DEVELOPMENT REVIEW BOARD REPORT

43-DR-2003#2
96th Street Improvements: Shea Blvd to Redfield Rd

Request approval for round-about & gateway features (including streetlight poles), colors & materials for improvements on 96th St from Shea Blvd to Redfield Rd .

MONUMENT DETAILS SHEET MD-1

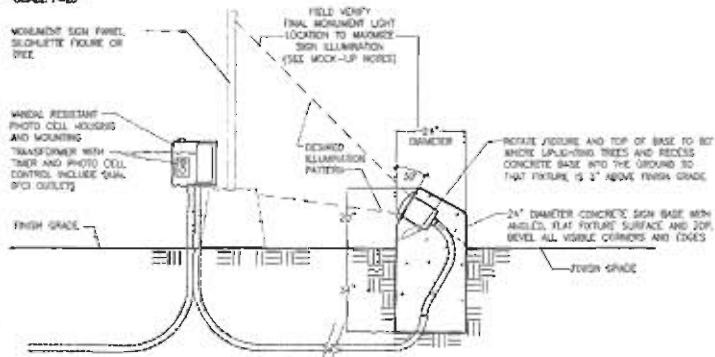
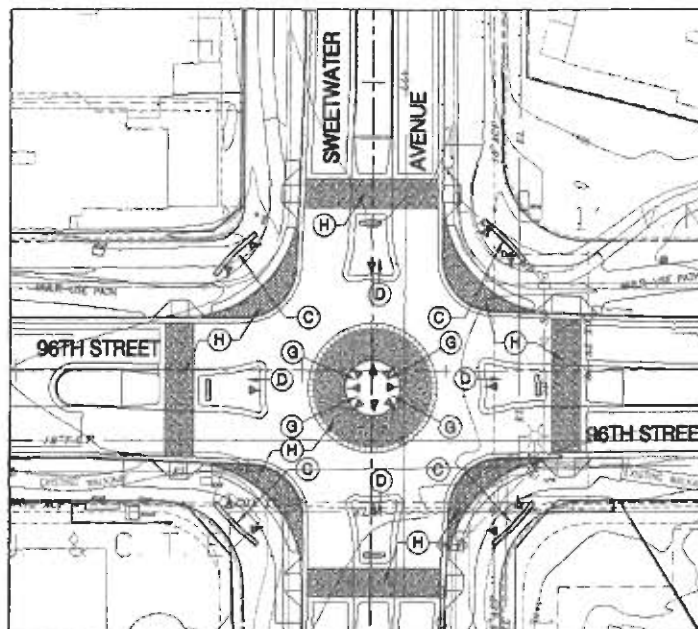
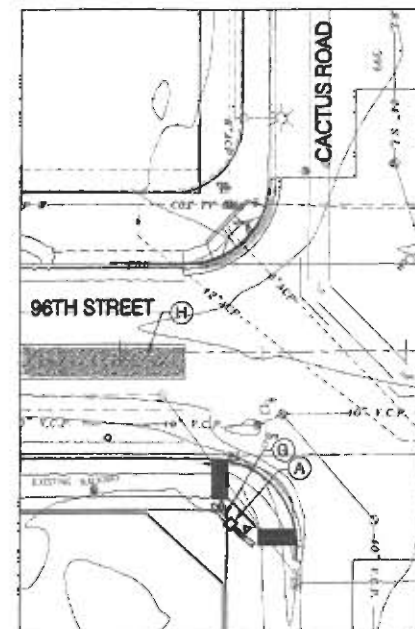
6-foot high masonry screening wall. This wall is proposed at the right-of-way line in back of the Cactus Acres monument on the northeast corner of 96th Street and Cactus Road. The proposal does not specify any materials or finish for the wall.

- *The City Code, Section 47. Encroachments, limits the height of concrete masonry or block walls to 2 feet above the adjacent curb in the public right-of-way. If the wall is on the property line of a single-family residential lot, then the Zoning Ordinance regulates the location and height of walls, and allows a 3-foot maximum height in the front yard of this lot facing towards Cholla. The wall will need to be designed in consideration of the City Code and Zoning Ordinance allowances.*
- *This wall needs to be finished on the inside and outside with a masonry finish or stucco treatment. The colors should complement the project colors on the outside facing the right of way; and the development colors on the inside facing the private property.*

2. All exterior conduit and raceways shall be painted to match the structure or monument or pole to which the conduit or raceway is attached or located with.
3. Dooley wall fencing shall not be allowed.
4. The wall shown at the northeast corner of 96th Street and Cholla Road shall be finished on all sides with a masonry finish or stucco treatment. The colors of the wall shall complement the project colors on the outside facing the right of way; and the development colors on the inside facing the private property. Wall finish and materials shall be subject to approval at the time of final plans review.

The proposed lighting will provide illumination of many of the design elements, illuminating them for drivers and pedestrians, as well as providing an enhancement for the design. The lights will be mounted in a 1½ foot high by 24-inch diameter concrete sign base, engineered so that the base becomes the light fixture and the light face is flush to the base. Field construction and setting of

the base will be a key factor in ensuring the correct portion of the design element is illuminated.

- *The lighting is directed upwards, and is not shielded. The zoning ordinance limits this type of lighting to no more than 100 wattage lights.*

- a. All landscape lighting directed upward shall utilize the extension visor shields to limit the view of the lamp source.
- b. Landscaping lighting shall only be utilized to accent plant material and monuments.
- c. The landscape lighting lamp shall be an incandescent or halogen incandescent source, and shall not exceed 50 watts.
